Request For Information

RFI-069

Subject: BP3 Steel Reconciliation Conf
Project: Steamboat - BV BP Promenade and Goldwalk
Address: 2305 Mount Werner Circle
Steamboat Springs CO 80487 USA
Phone:
To: Jim Gray
Zimkor, LLC
From: Saunders Construction, LLC

1A-S4.01

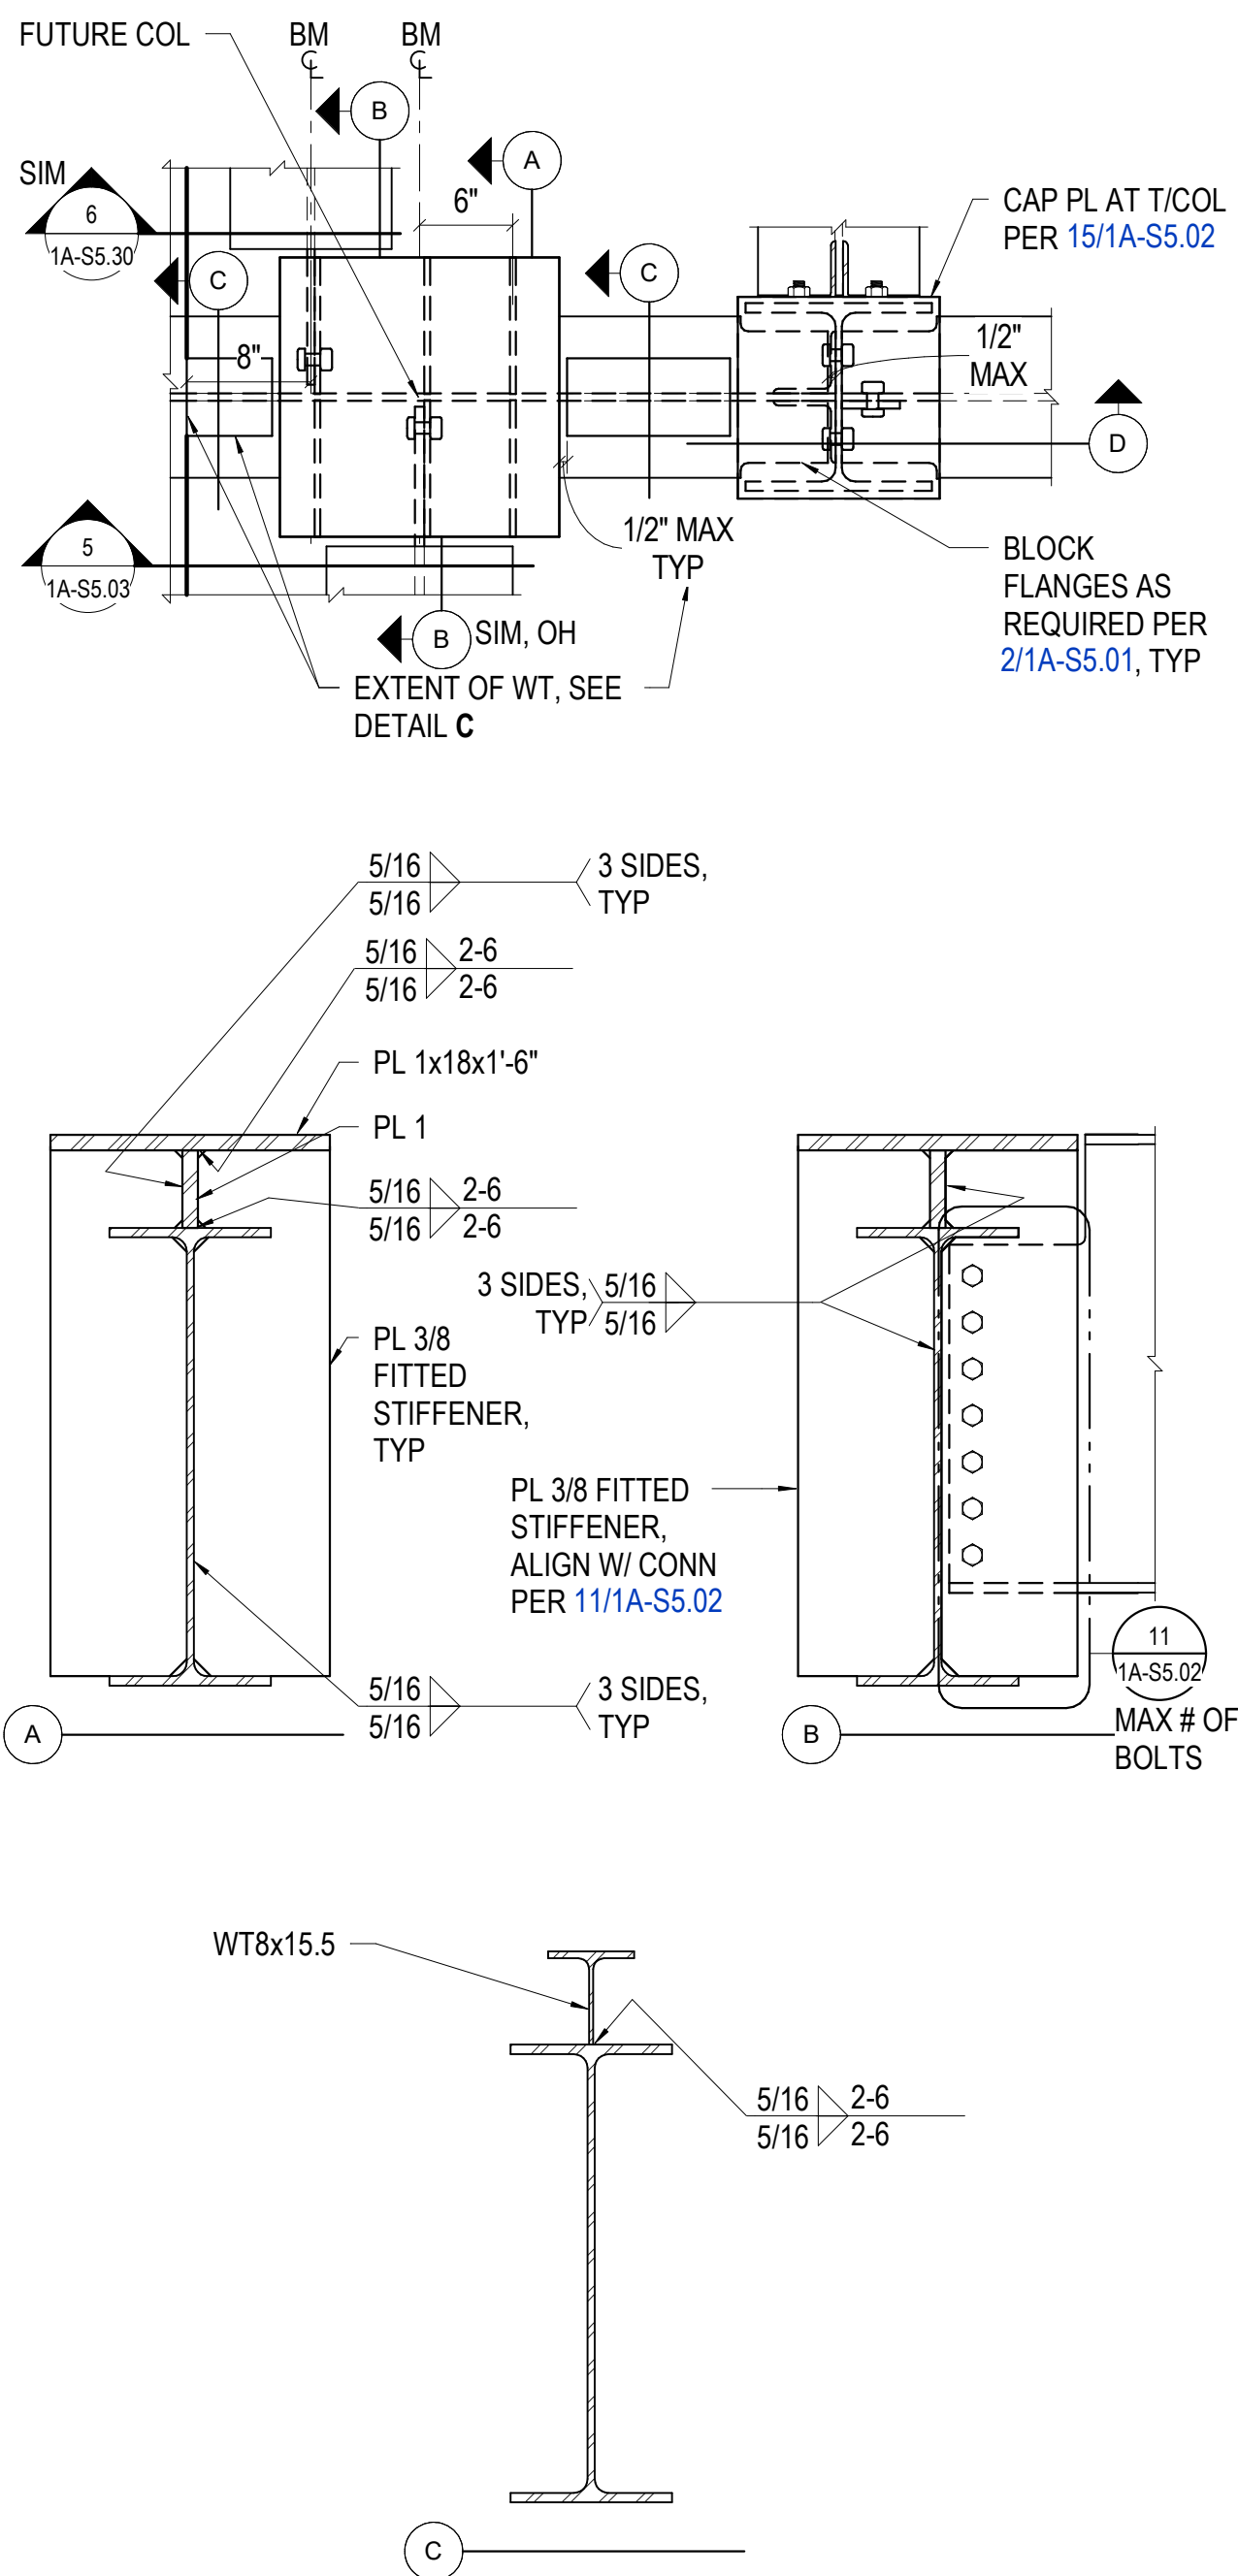
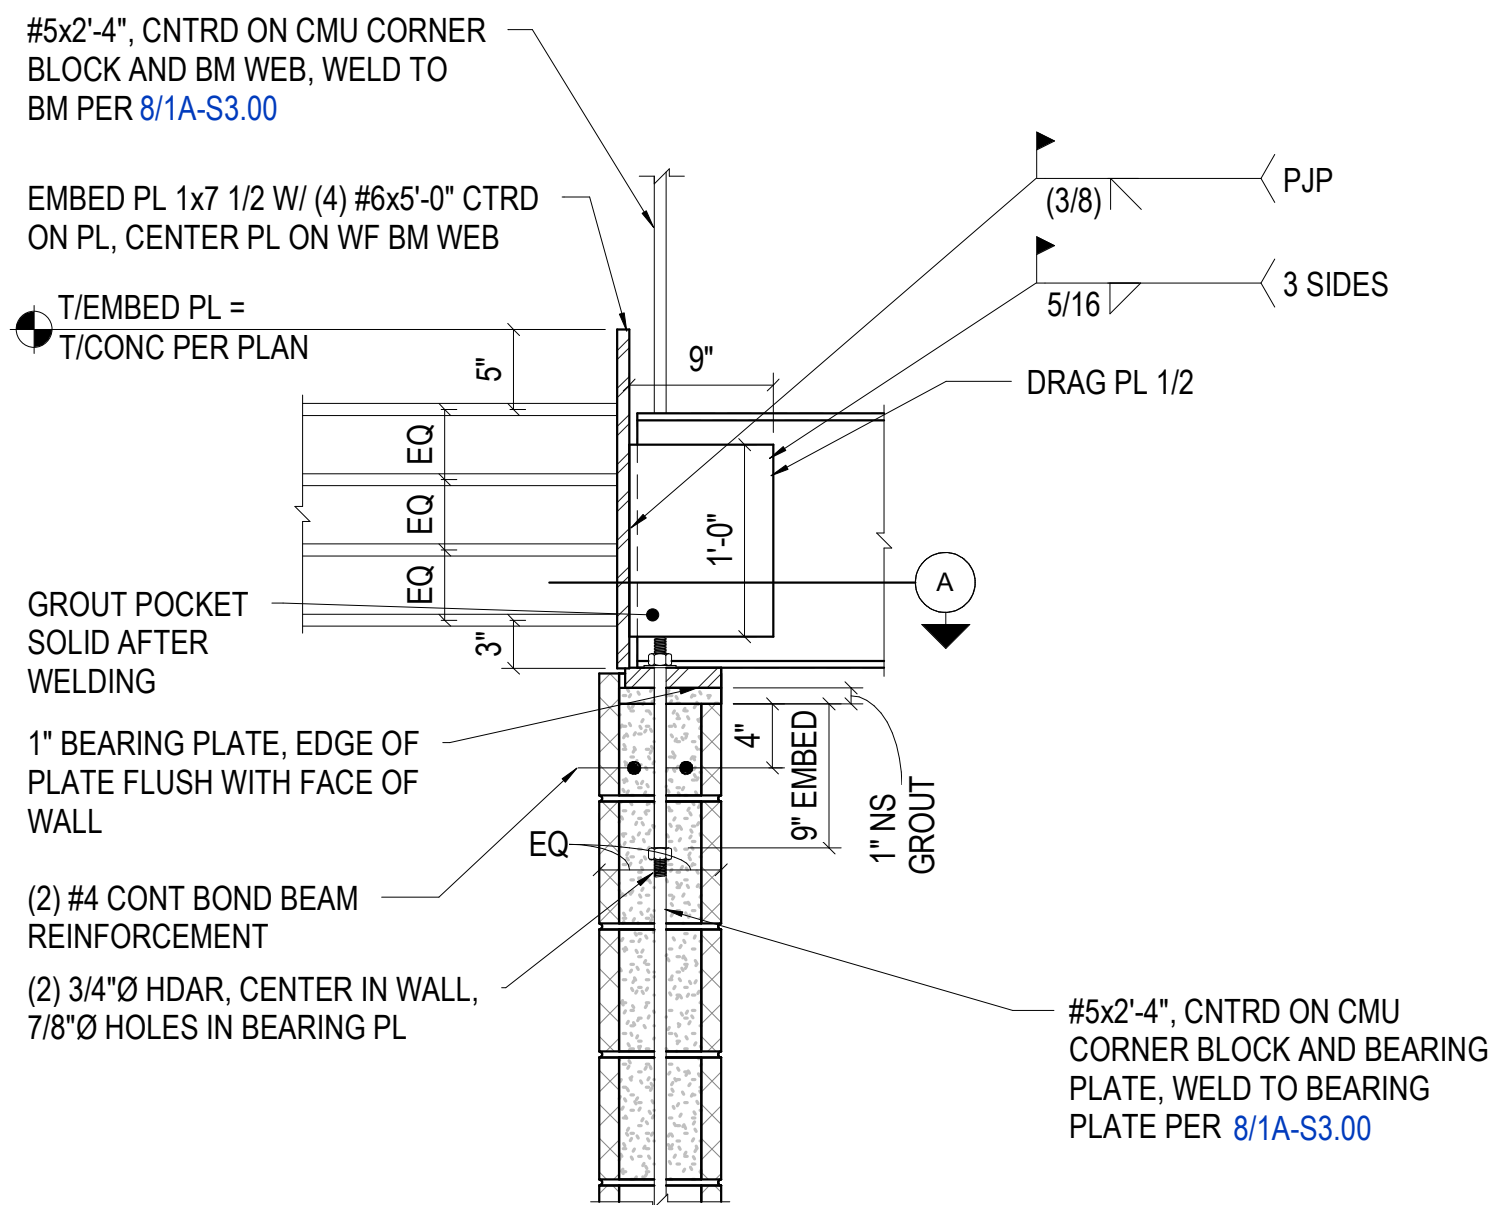
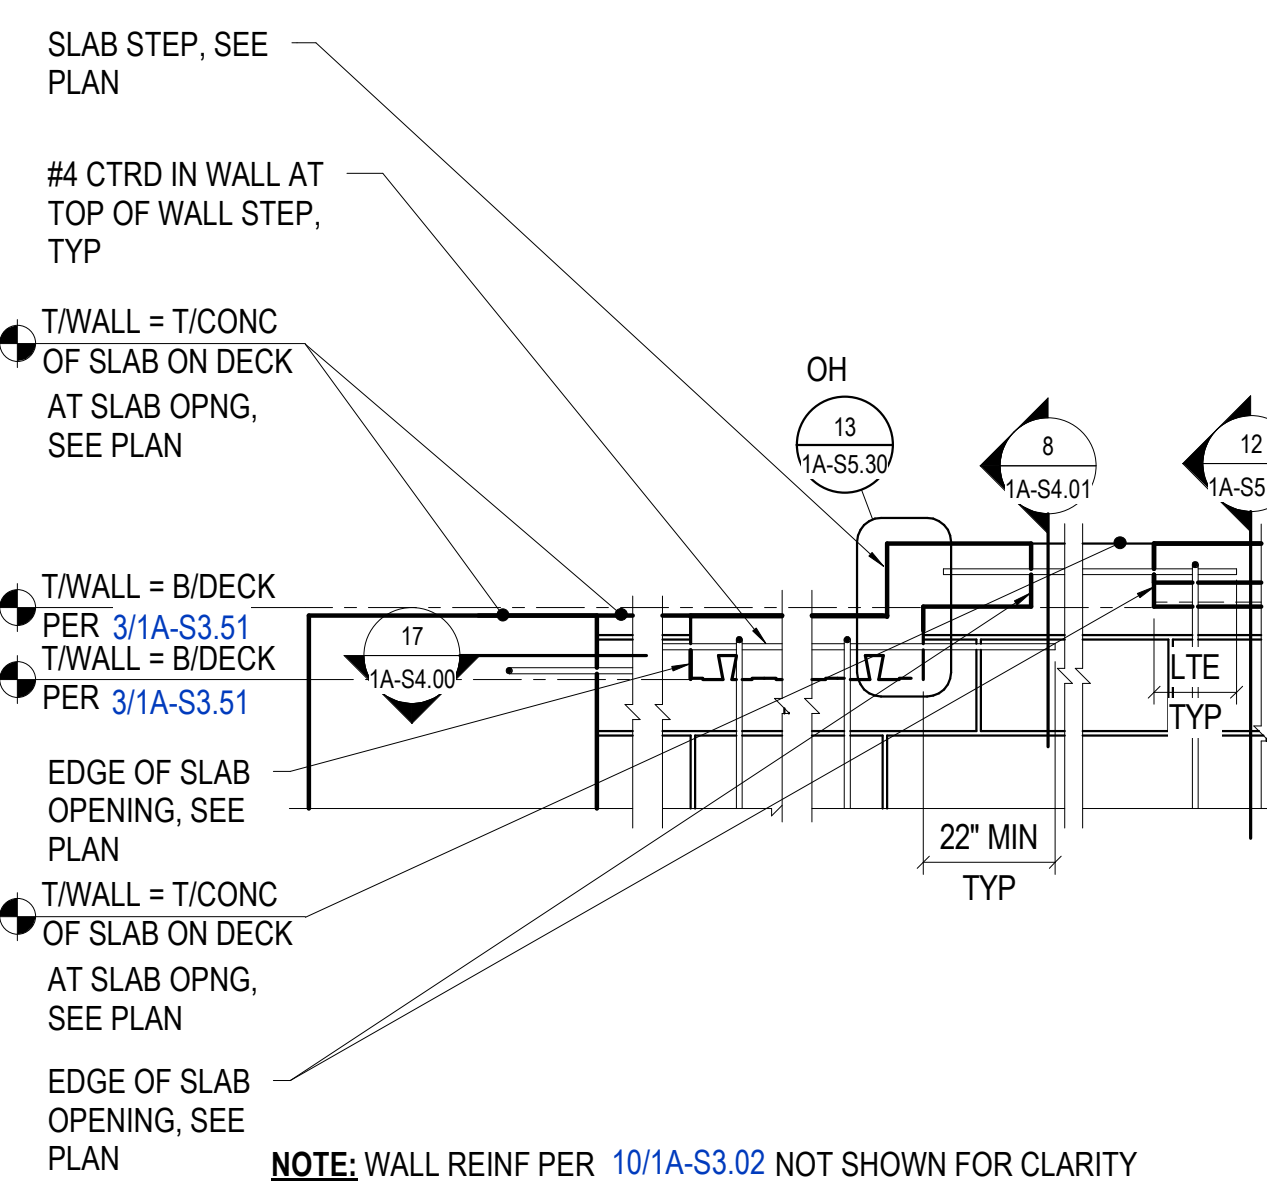
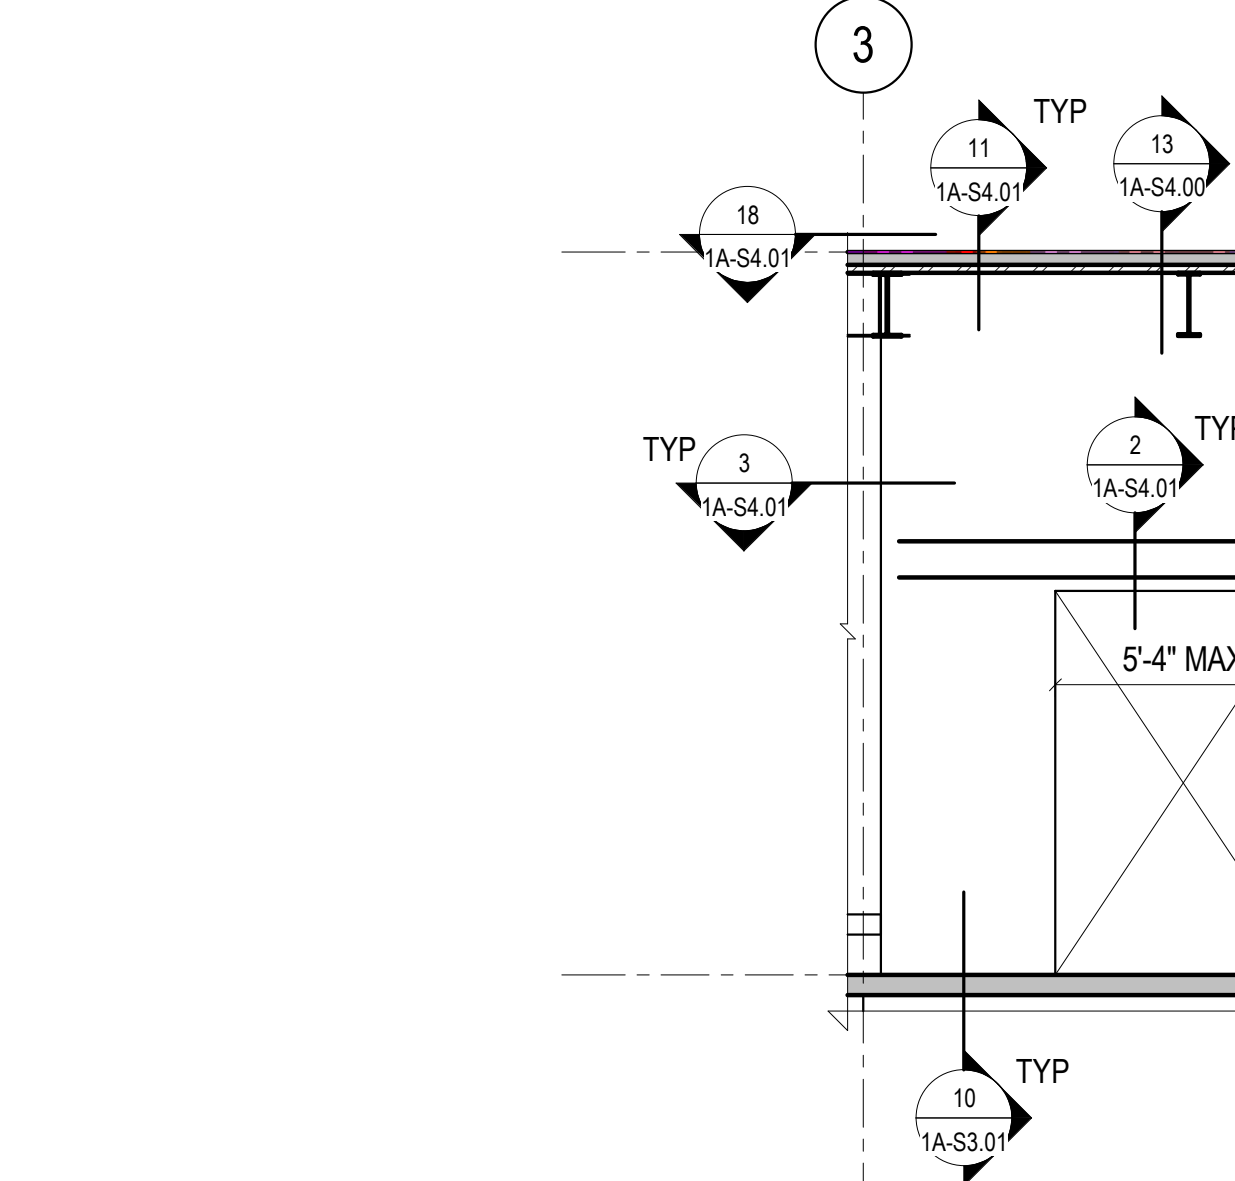
Following release of Promenade Bulletins 5 & 7 further structural steel and foundation changes were needed to be made in order to reduce schedule impact associated with design changes. Please confirm the attached print with updated sheets 1A-S1.00, S1.01, S4.01, S5.02, S5.03 and S5.30 is the final change document to be followed.

CONFIRMED.
KK/MM 8/19/21

SEE ATTACHED DRAWINGS WITH CORREC TITLE BLOCK
JAPPLE GENSLER 8/20/21
